ECE/TRANS/WP.29/GRPE/2009/2  
4 November 2008

GLOBAL TECHNICAL REGULATION No. 2 ON THE  
WORLD-WIDE HARMONIZED MOTORCYCLE EMISSION TEST CYCLE

Proposal for draft Corrigenda to global technical regulation No. 2

Submitted by the expert from Germany<sup>1</sup>

**Figure A13-1: Example of a gearshift sketch**

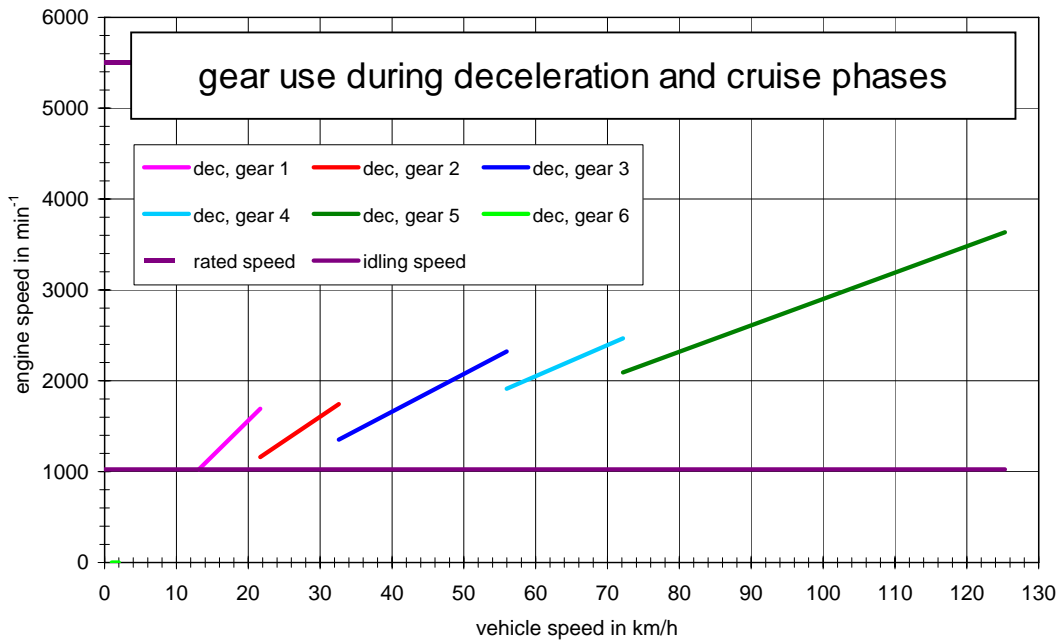
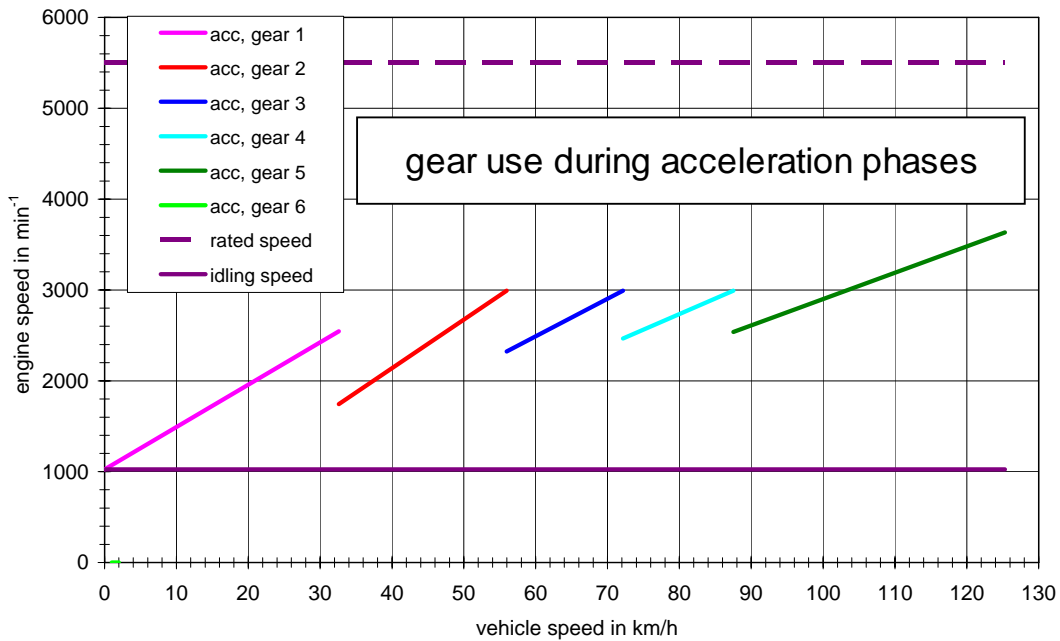
**Figure A13-1 shows an example of gearshift use for a small vehicle.**

- (a) The lines in bold show the gear use for acceleration phases.**
- (b) The dotted lines show the downshift points for deceleration phases.**
- (c) The cruising phases the whole speed range between downshift speed and upshift speed may be used.**

**Figure A13-2: Example for modified phase indicators**

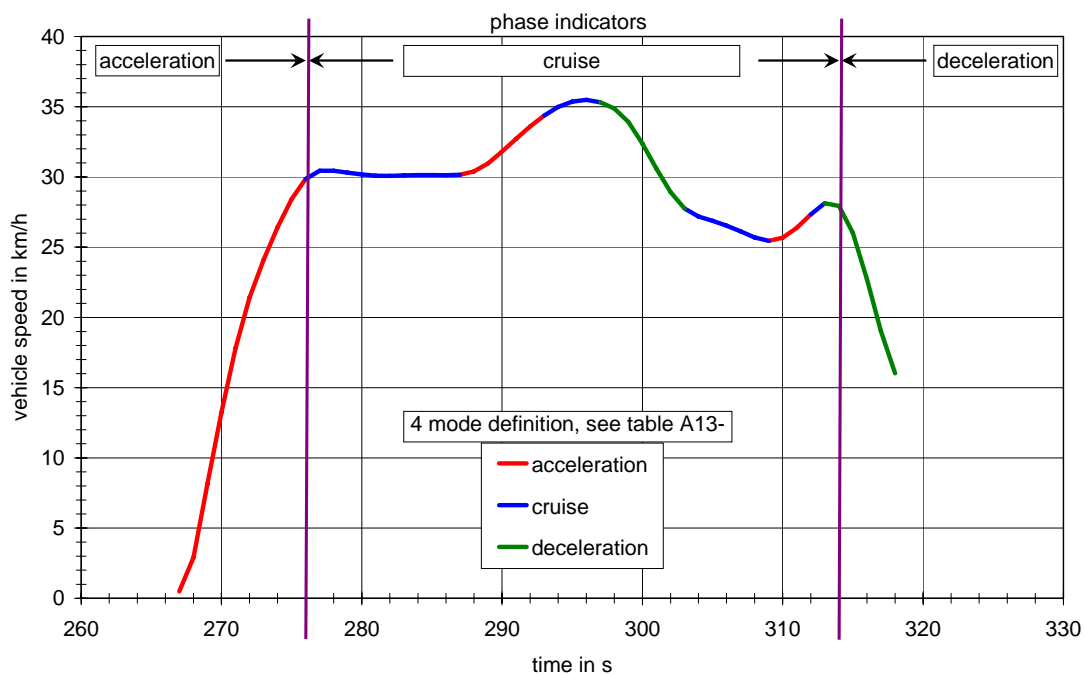
The indicators were then modified in order to avoid frequent changes during relatively homogeneous cycle parts and thus improve the driveability. Figure A13-2 shows an example from cycle part 1.
